Correspondence
Support

RE: Case Number C814-86-023.01

RE: Shepherd Mountain / SPC-2017-0239C

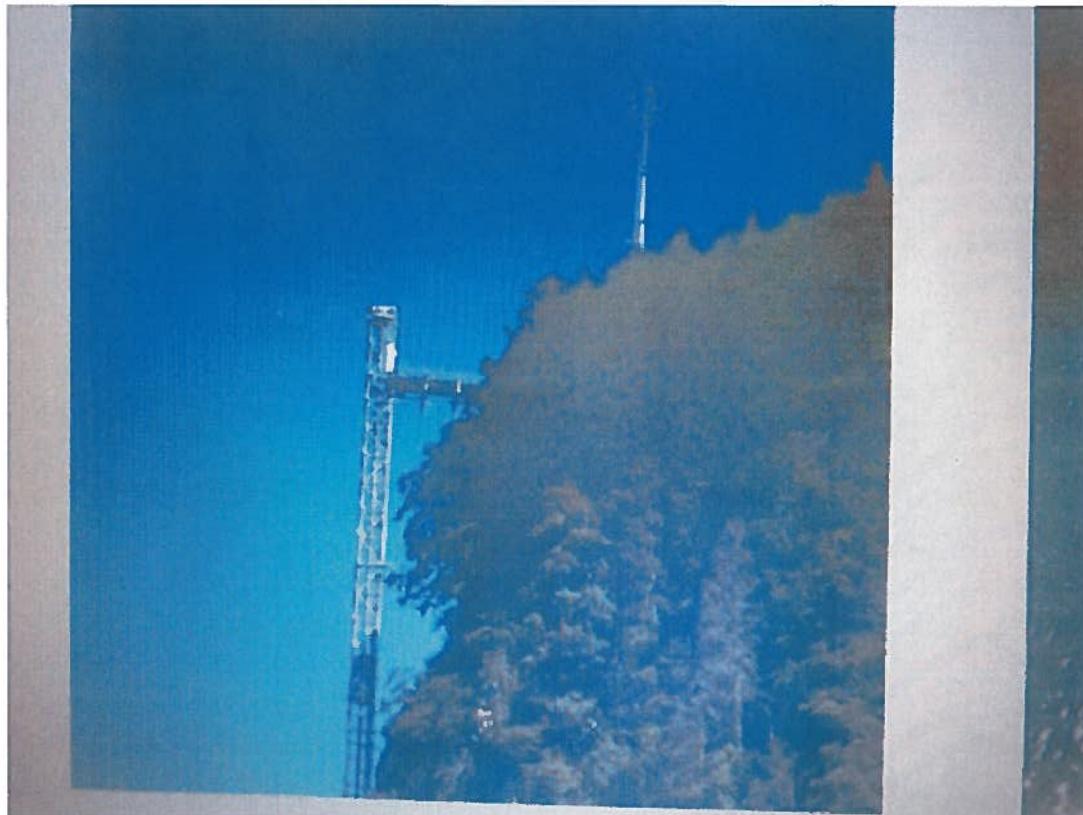
Mr. Coon is intending to build a 624' long marina on Lake Austin, the longest there would be. He is asking also for the possibility to extend it 100' into the lake, which is roughly 20% of the width of the lake! There will be no roads going into this marina, as the topography makes it impossible. The only access would be through a mechanical elevator that would be roughly 180' tall (~15 stories), that would connect to the top of the cliff with a bridge. The marina is planned to be good for 24 boats and would include: bathrooms, a swimming area, a kitchen, and 7,500 square feet of recreational space for "people to hang out".

I do not see how this monstrosity would address FIRE or EMS emergencies. No roads can be built on the vertical face of the rock rim. This place would be a fire trap next to acres of our urban forest, with no possible way to get to it, or out of it.

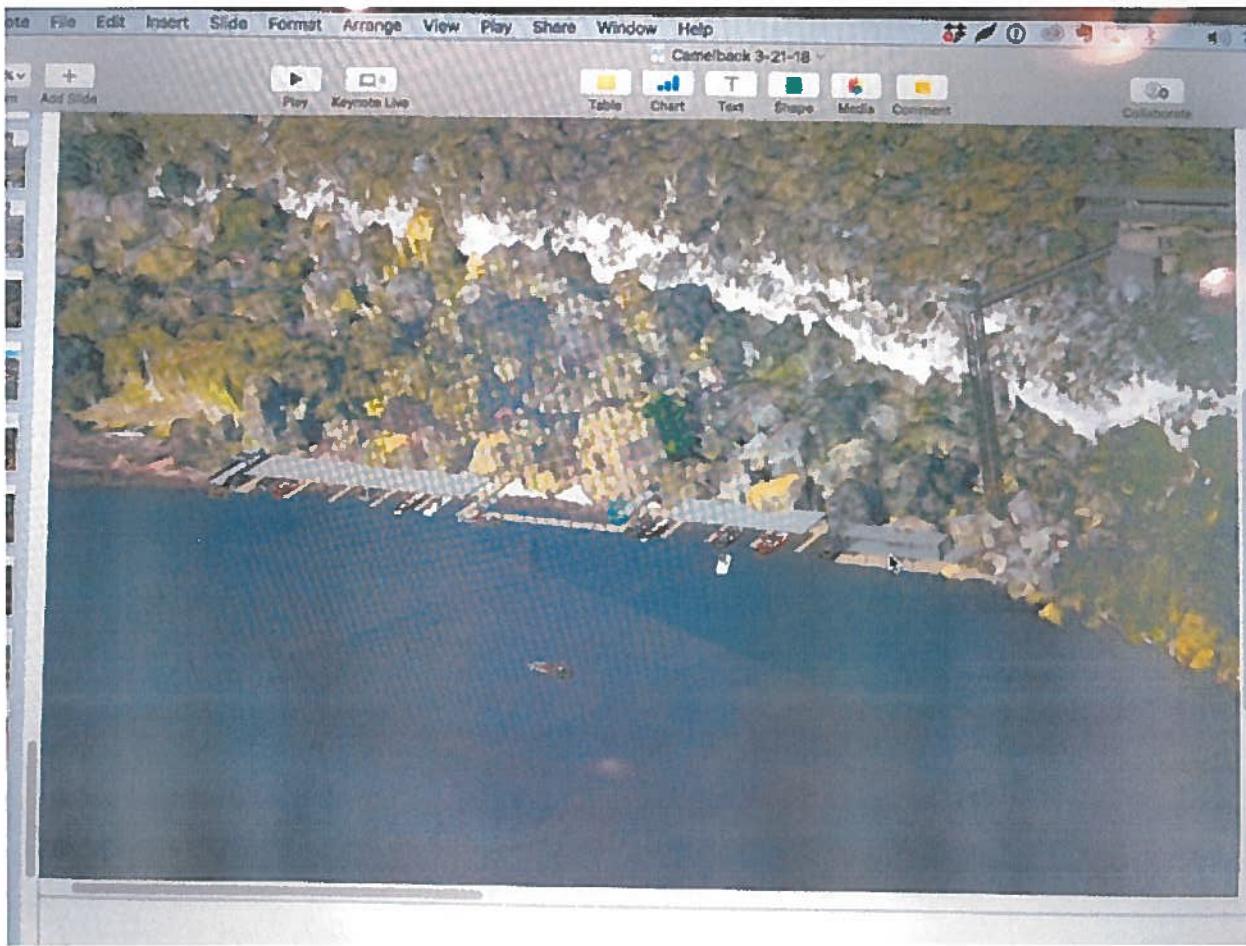
The next picture is also Mr. Coon's. It is a computer generated rendering of his vision of this fire trap he intends to build. The elevator, the bridge to access it and the massive commercial marina with its party pavilion, kitchen and swimming area can be seen in it.

Can people cook and grill here? What happens if there is a fire? How quickly would that heavily vegetated vertical forest on the cliff go? Where are the mechanical rooms that move the elevator and pump the sewer waste up the hill? Are they electrical; can they catch fire? Are we facing biological hazards (bathroom on the lake)? Can people swim at this facility? How do you rescue someone in the event of a drowning accident, a chocking incident, or any other emergency? Will the AFD engineering prevention department review the specifications of the elevator as to its suitability to carry emergency crews and equipment? How do you evacuate a stuck elevator? Who evaluates the elevator as a reliable and safe access to the boat docks (if functionality is compromised by either fire or mechanical problems during an emergency situation there would be no access or escape from the marina)? Are there fire lanes and an access road to the elevator including a turnaround area?

**CAMELBACK PLANNED UNIT DEVELOPMENT
ENVIRONMENTAL RESOURCE EXHIBIT**

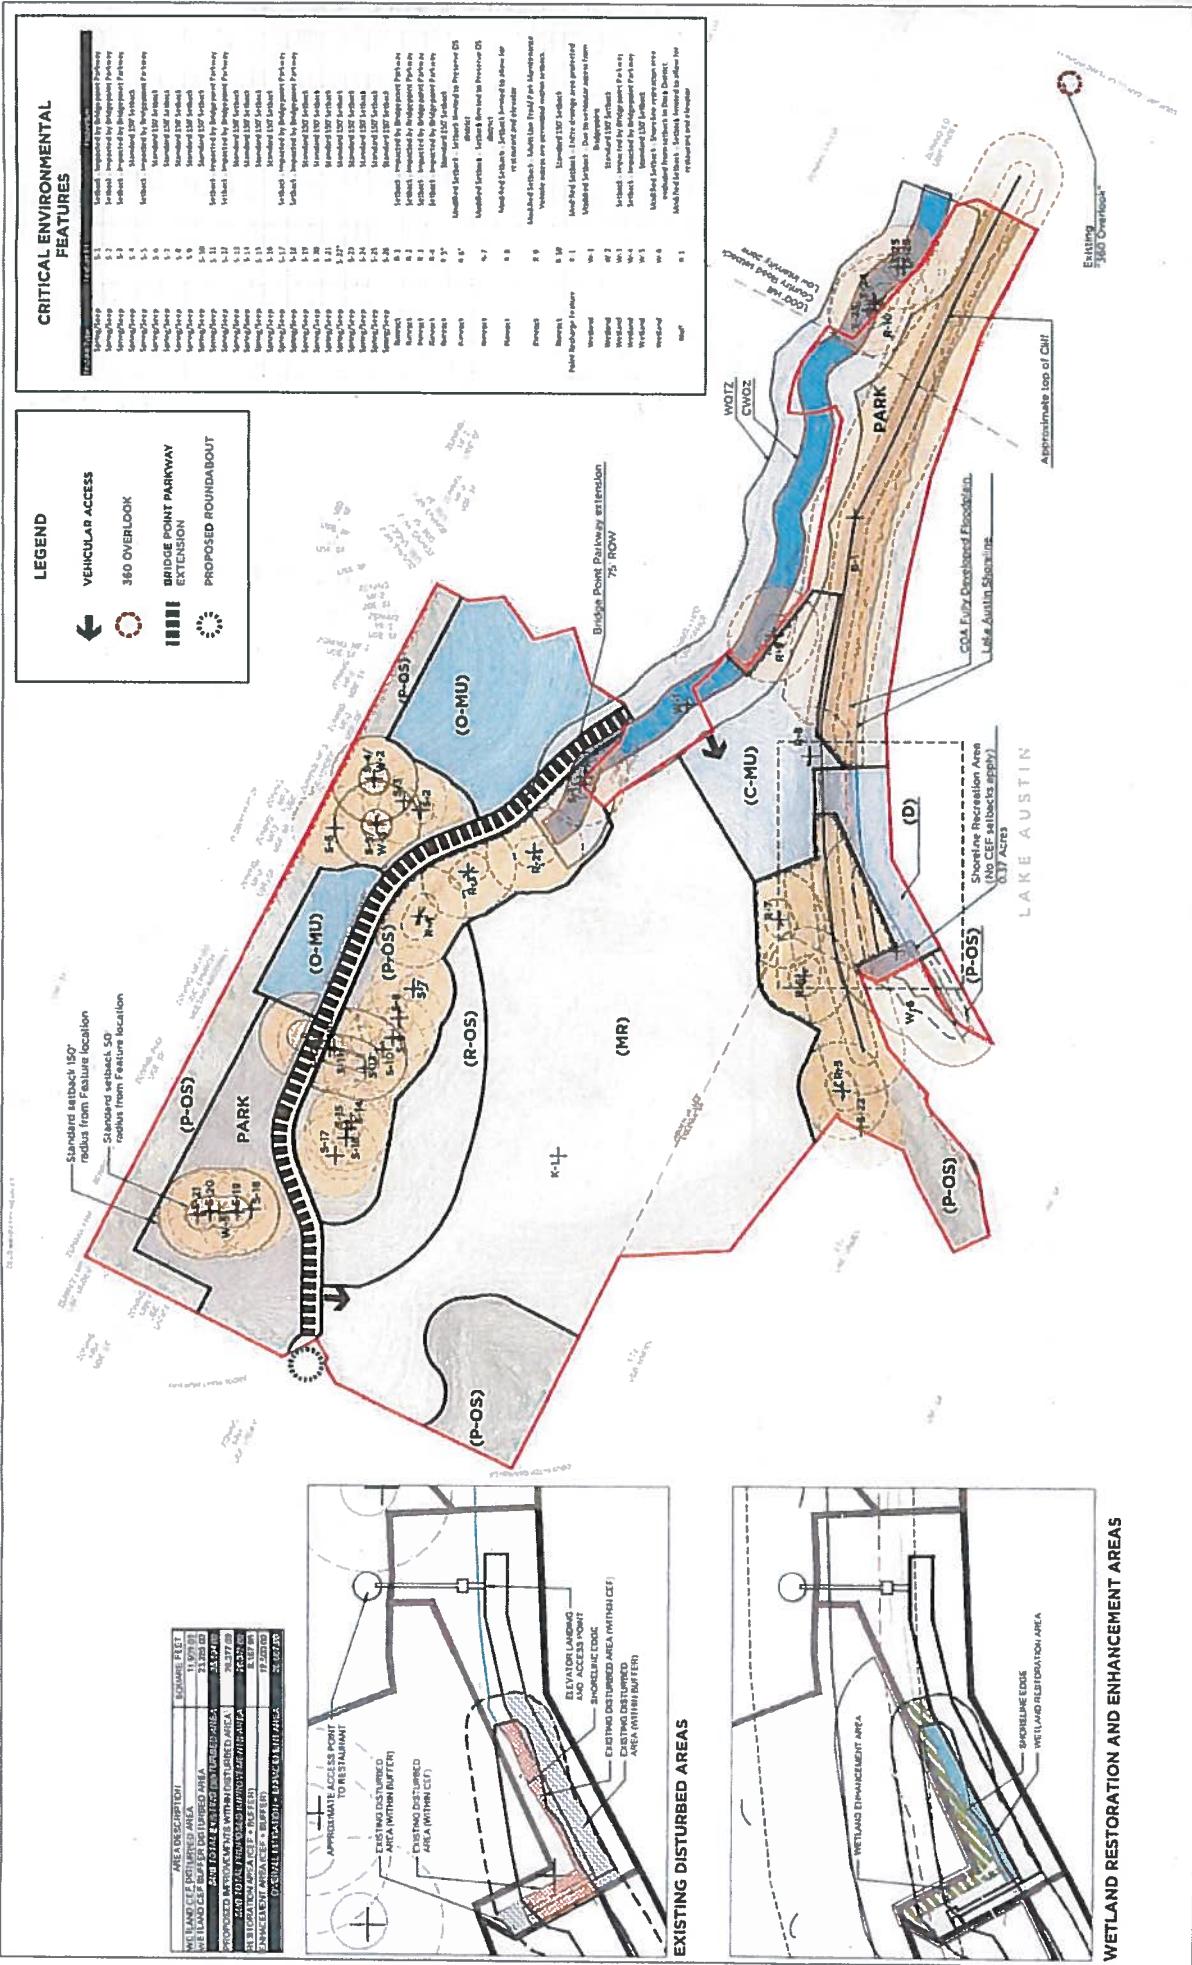
- **Modifications reducing wetland and Bluff Critical Environmental buffer setback allowances. Specifically, CEF W-6. (See Applicant's Map #2, "Environmental Resource Exhibit and 8-31-18 Planning & Zoning Response Comment Report, WB 11)**
